*Sizewell C (SZC)*

*Deadline 5 – 23 July 2021*

East Suffolk Council comments on Deadline 3 and 4 submissions from the Applicant

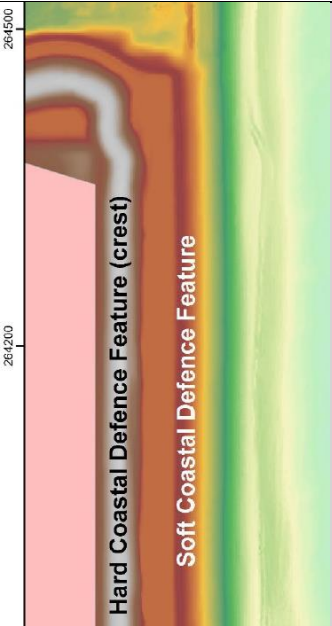
5	Fig. i	<p style="text-align: center;"><b>TR544: PRELIMINARY SCDF DESIGN</b></p> <p style="text-align: center;"><b>NOT PROTECTIVELY MARKED</b></p>  <p>Figure i: Schematic cross-section of the hard and soft coastal defence feature (HCDF and SCDF). The SCDF (yellow) is conceptually divided into two volumes, separated by the dividing SCDF recharge threshold (as the threshold is volumetric, the line is shown for illustrative purposes only, i.e., many different beach profile shapes can produce the threshold volume). The SCDF buffer layer (whose volume is <math>V_{\text{buffer}}</math>) sits to landward and is not intended to be exposed, whilst the SCDF sediment to seaward is sacrificial (<math>V_{\text{sac}}</math>) and would be replenished once the recharge threshold has been reached. The dashed green line running through the yellow SCDF is the present-day topographic cross-section.</p>
		<p><u>Accepting that the diagram is schematic, it nevertheless begs a number of questions:</u></p> <p>The HCDF structure appears to be drawn to natural scale, e.g. with a 1:3 seaward slope. Equally the seaward face of the Sacrificial layer at ~1:1 is not unreasonable. The principle of “volume definition” is reasonable but the schematic is misleading in respect of the implied SCDF threshold (even with the caveat):</p> <p>Clarification sought, preferably by production of a more realistic illustration that uses natural scale throughout.</p>

<p>The caption says that many different profile shapes can produce the threshold volume. However, unless the Buffer layer has a different sediment composition it would follow a similar profile to that of the Sacrificial layer. In practice it would require the buffer to be greater than a minimum set volume to be accommodated to avoid interference with terrestrial features, e.g. coastal path - the suggested 80m<sup>3</sup>/m could be challenging.</p> <p>Later in the report, reference is made variously to a “sacrificial buffer”. Taken to mean the sacrificial layer, this use of mixed terminology has potential to confuse.</p> <p>There is no consideration in report of SCDF viability with an adapted HCDF profile.</p> <p>Two points in relation to “landscaping”: The coastal path runs beneath the landscaping! The landscaping runs over the crest at a thickness of 2m or 2.9m if the unlabelled layer beneath it is also landscaping. If not removed before the HCDF becomes an active defence, this material could seriously affect the hydraulic performance of the HCDF (run up and overtopping).</p>	<p>Recognition that there are practical limitations due to the seaward slope assumption for the buffer layer.</p> <p>Clarification of where is the buffer considered to end at its “landfall”.</p> <p>Address the use of mixed terminology (buffer/sacrificial) to ensure consistent use throughout the report.</p> <p>Include a Section in the report (or TR545) for design and viability of SCDF fronting an adapted HCDF profile.</p> <p>Clarification on the location of the landscaping in relation to the coastal path.</p> <p>Further information regarding long term future management of the landscaping layer.</p>

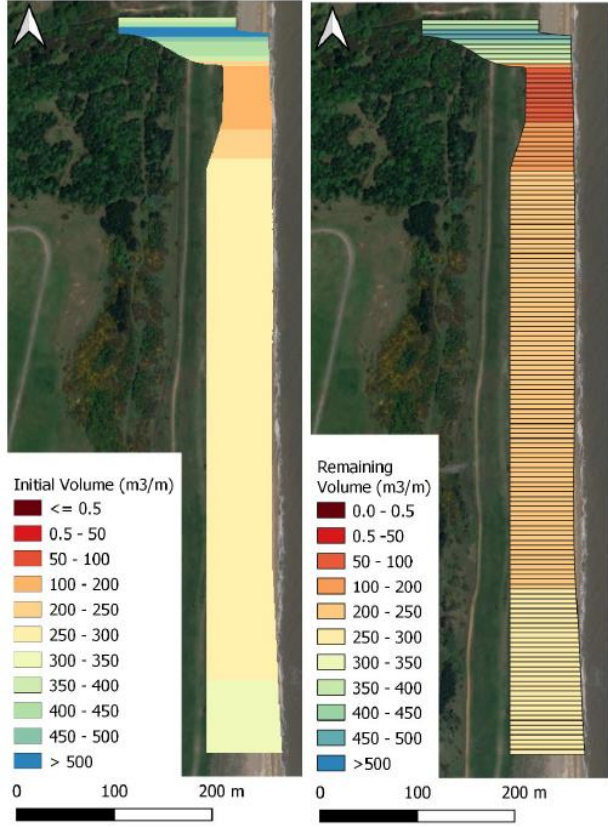
It is not clear whether these test runs have been used for the purposes of design. If so, it is not clear why the conditions are not extended to more/different JP extreme conditions than 1-in-20 years.

Clarification or further information sought.

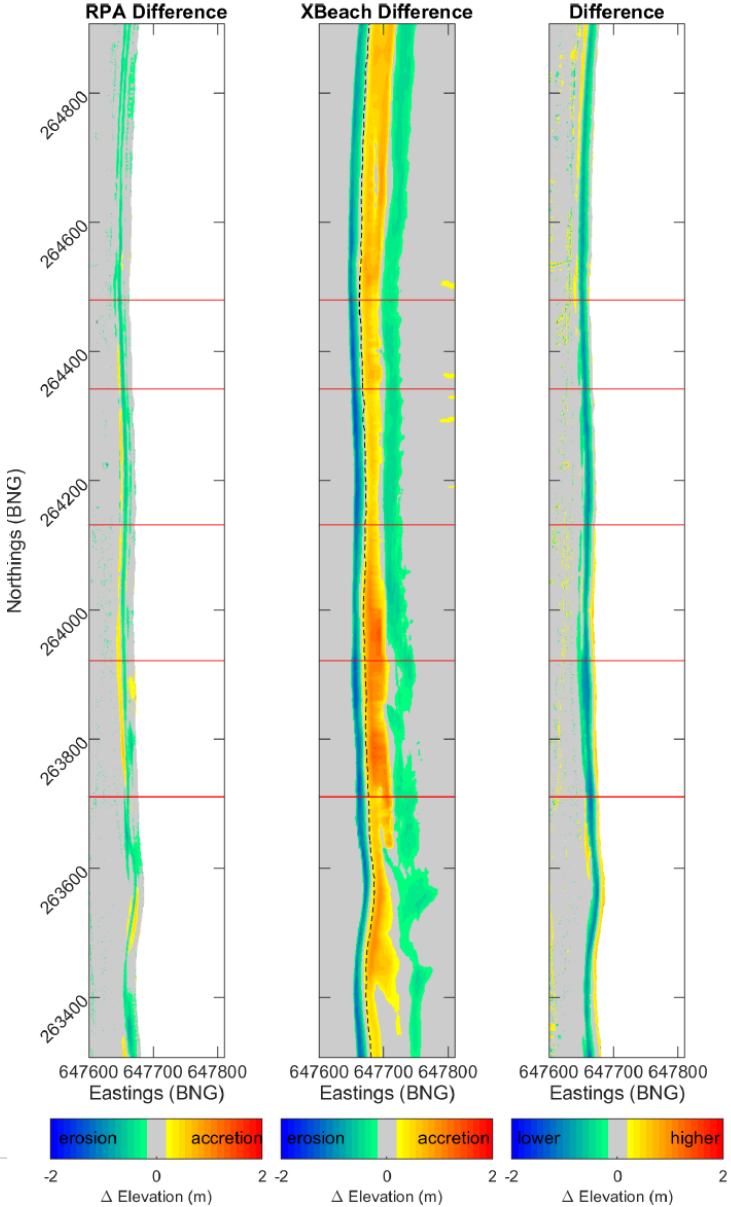
40	<p>3.1.1</p> <p>Fig. 3-1</p>		<p>The figures are very well presented.</p> <p>It would be useful to remind the reader of all the relevant key parameters applying to these run plots. In particular what grain size is being used. Same applies elsewhere.</p> <p>It is otherwise assumed to be a sand grade, judging by the form of erosion.</p> <p>It would help to match up the figures with the respective Scenarios as presented in tables 2-3 and 2-4.</p>	<p>Clarification on parameters sought – see to left.</p>
----	------------------------------	--	---	--

48	Fig. 3-7		<p>The results show an uncomfortable situation in the eighth panel where erosion is apparent right upon the HCDF. Even the SCDF (present?) is not encouraging in this respect. With a shore which is more retracted to the north, this would suggest the exposure of a hard point with potential to interrupt littoral drift.</p>	<p>Further explanation required.</p>
49	Fi. 3.8	<p>Figure 3-8 Cross sections of bed level change for the North East 1-in-20 year storm, 2099 Sea Level (left panels) and South East 1-in-20 year storm, 2099 Sea Level (right panels) for the SCDF with present-day ('SCDF') and future eroded shorelines ('SCDF future'). Top panels: Comparison of changes in bed elevation during the simulated storms at the middle of the SCDF frontage (Y2). Second from top panels: Comparison of changes in bed elevation during the simulated storms averaged along the SCDF frontage (Yaverage). Third from top panels: Comparison of post-storm bed elevations during the simulated storms at the middle of the SCDF frontage (Y2). Bottom panels: Comparison of post-storm bed elevations averaged along the SCDF frontage (Yaverage). The red solid line in each panel shows the difference between the cases with present-day and future eroded shorelines.</p>	<p>The caption reads thus:  <i>3-8. Cross sections of bed level change for the North East 1-in-20 year storm, 2099 Sea Level (left panels) and South East 1-in-20 year storm, 2099 Sea Level (right panels) for the SCDF with present-day ('SCDF') and future eroded shorelines ('SCDF future'). Top panels: Comparison of changes in bed elevation during the simulated storms at the middle of the SCDF frontage (Y2). Second from top panels: Comparison of changes in bed elevation during the simulated storms averaged along the SCDF frontage (Yaverage). Third from top panels: Comparison of post-storm bed elevations during the simulated storms at the middle of the SCDF frontage (Y2). Bottom panels: Comparison of post-storm bed elevations averaged along the SCDF frontage (Yaverage). The red solid line in each panel shows the difference between the cases with present-day and future eroded shorelines.</i></p>	<p>The change profiles as highlighted show essentially nil change between the present day and future cases (both with SCDF).</p> <p>Although depicting some change it is also negligibly small for the NE storm. Please clarify how this can be so.</p>
